**Zilker Neighborhood Association
Notes on Post PUD Application, March 9, 2013**

Case Number: C814-2012-0160

As representatives of the owners of the above stated Property, we respectfully submit the enclosed Planned Unit Development ("PUD") application packages. The project is titled 211 South Lamar and is located at the southeast corner of South Lamar and Riverside. The PUD proposes a rezoning of the Property from CS, General Commercial Services, and CS-V, General Commercial Services – Vertical Mixed Use, zoning to PUD, Planned Unit Development District, zoning. The Property is currently developed as a Taco Cabana restaurant and surface parking lot. The owner intends to develop the Property with a mixed-use building.

LAND USE PLAN

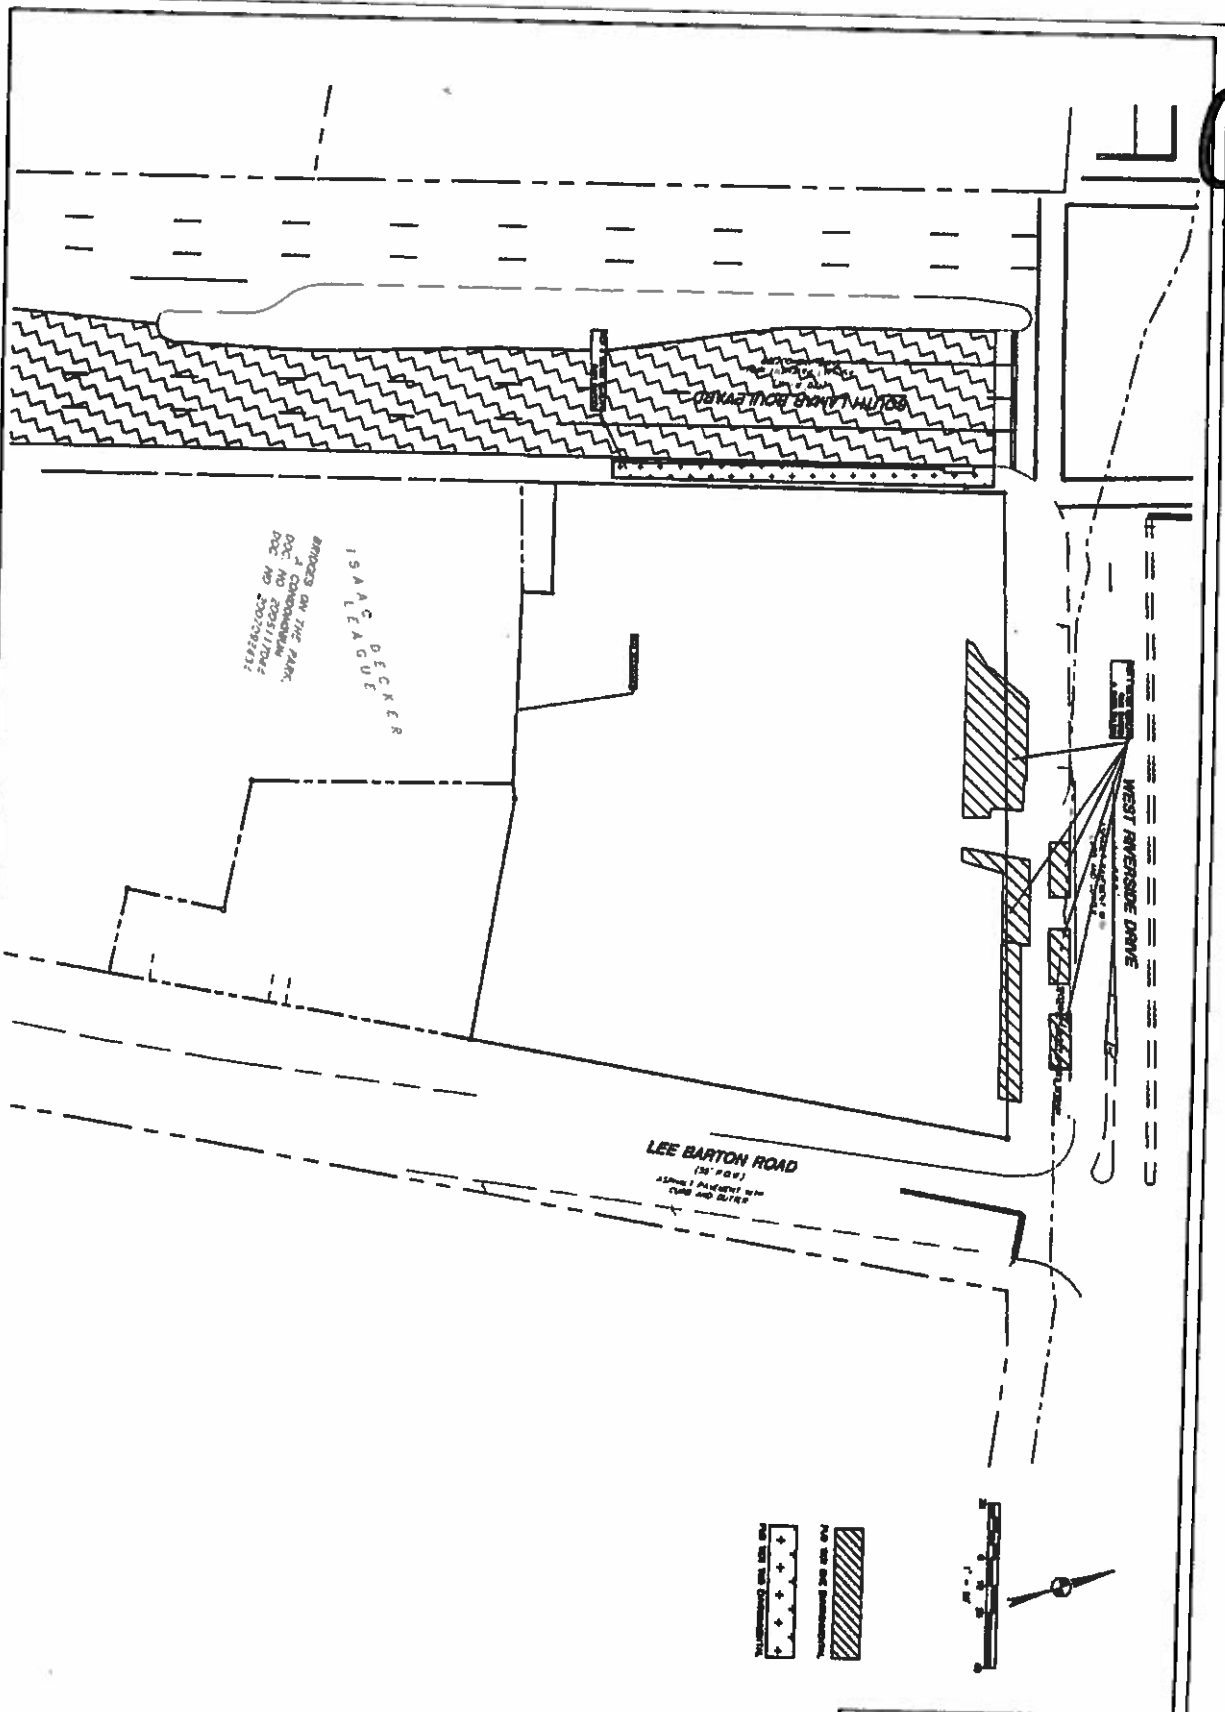
- q. II.11. Do we deduce that 2.5% of 175 units (4.3) is rounded to 4 or 5? Clarify if you can.
3. Land Use Plan Comments – Sheet 1
- a. Please clearly distinguish existing versus proposed land use; separate schematics on the same sheet would be ideal. Clearly depict PUD boundary (heavier line) and future building lines. What's the buildable area? Is there a setback from the Bridges building? Please label Paggi House and Bridges buildings as existing. Identify Fast Food Restaurant as Existing.

- h. Note # 32: Please highlight trees in Sheet 1 schematics. See also 6a, below.
- i. Note # 33/Variance to TCM9.3.0 #3: Is this a variance to zoning requirements or to site-planning requirements? If it is appropriate to consider at the rezoning stage, then provide the documentation from Transportation (see reviewer note #7) concurring with the proposal. If this is NOT a variance to the zoning code, but associated with site-planning, then please remove from plan sheet and table of CS variances.

- 3. Land Use Plan Comments – Sheet 1**
- a. Please clearly distinguish existing versus proposed land use; separate schematics on the same sheet would be ideal. Clearly depict PUD boundary (heavier line) and future building lines. What's the buildable area? Is there a setback from the Bridges building? Please label Paggi House and Bridges buildings as existing. Identify Fast Food Restaurant as Existing.**

- g. **Noted.**
- h. **Note # 32: Please highlight trees in Sheet 1 schematics. See also 6a, below.**
- h. **A new sheet has been added to the Land Use Plan clarifying tree preservation.**

WATER QUALITY PUD EXHIBIT

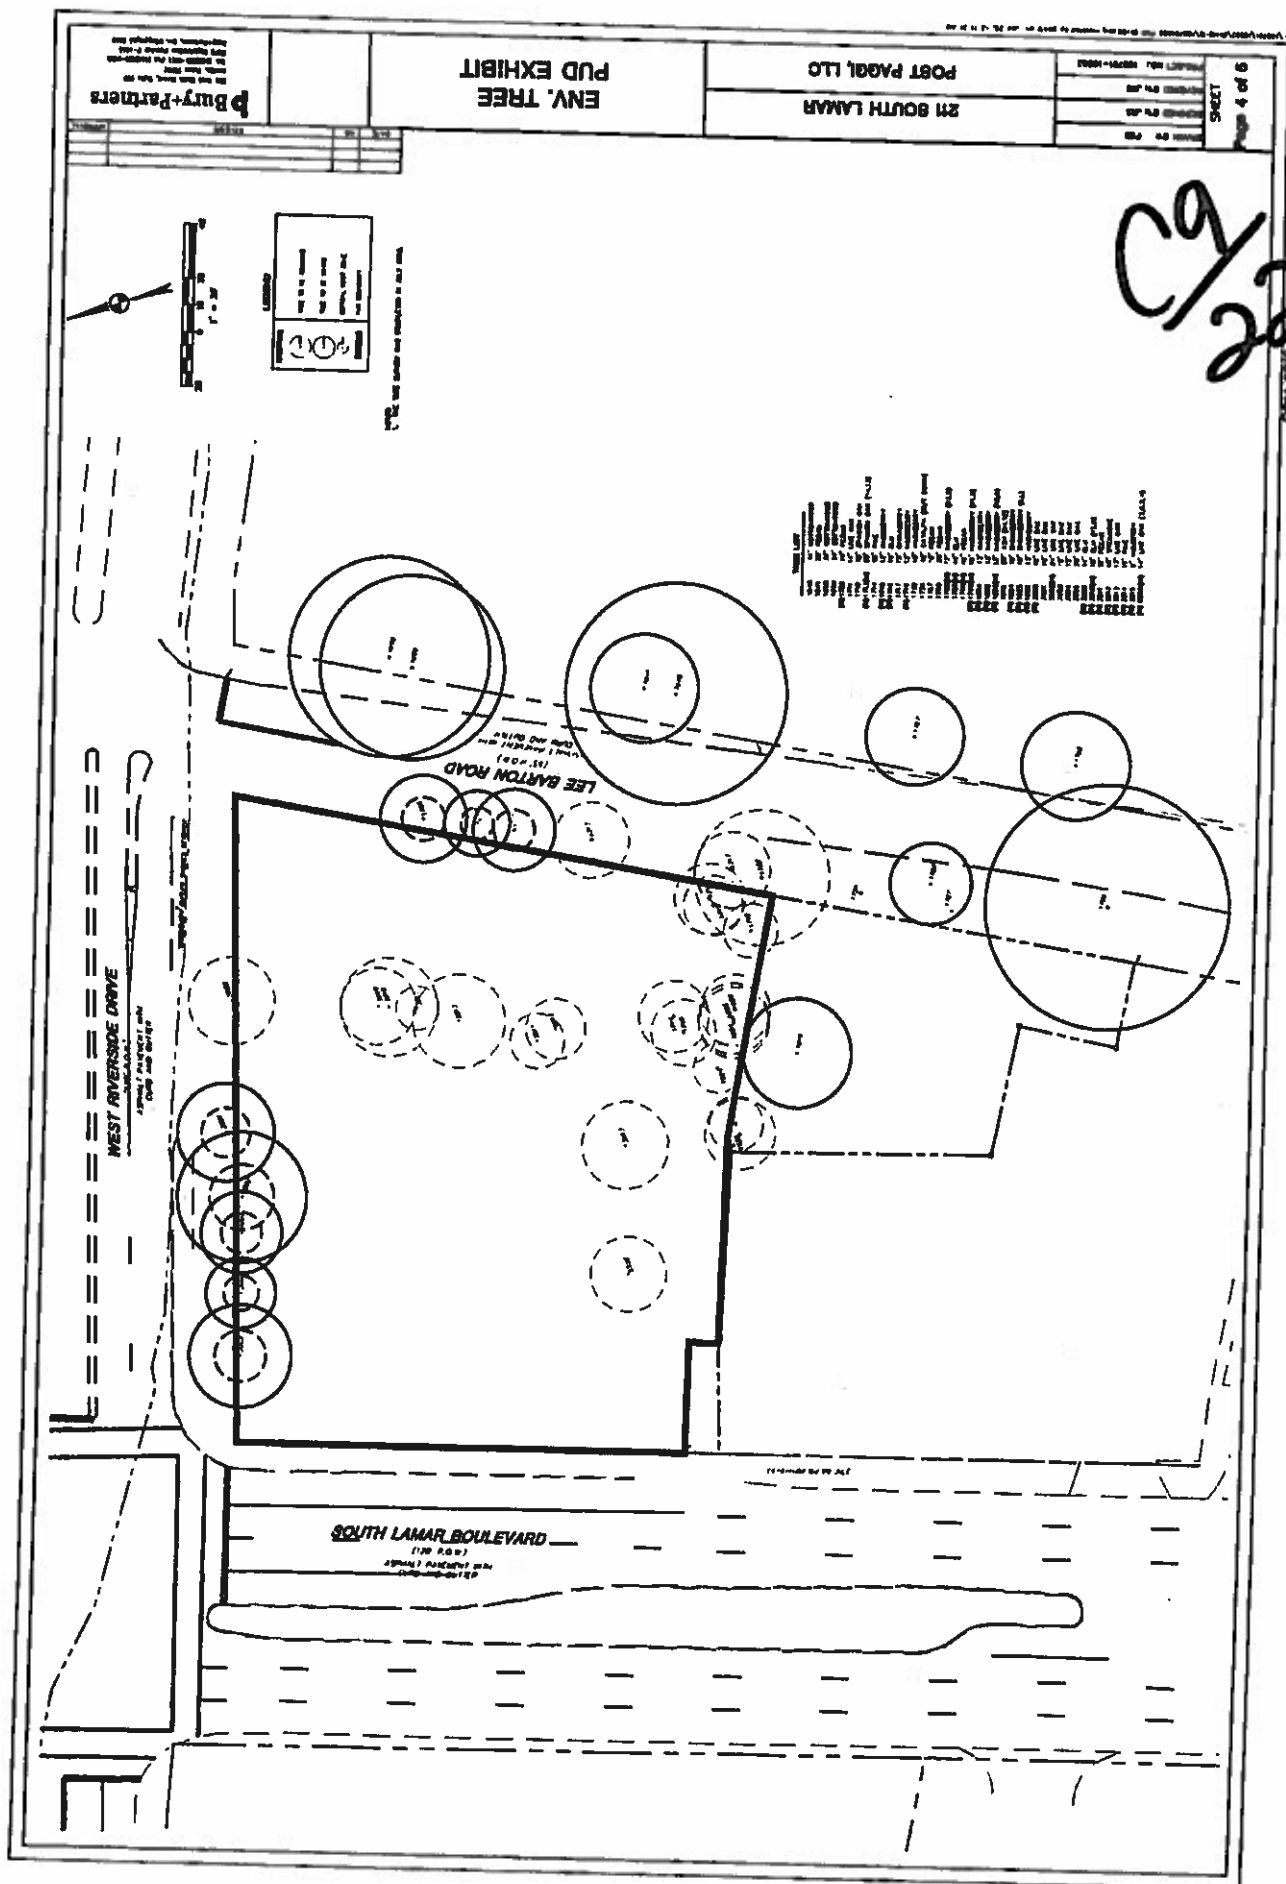
WQ 1. Include in the land use plan a water quality plan demonstrating how the Tier II requirements can be met including 25% additional water quality volume and 20 % greater pollutant removal as well as treatment of currently untreated off-site drainage areas of at least 25% of the subject tract.
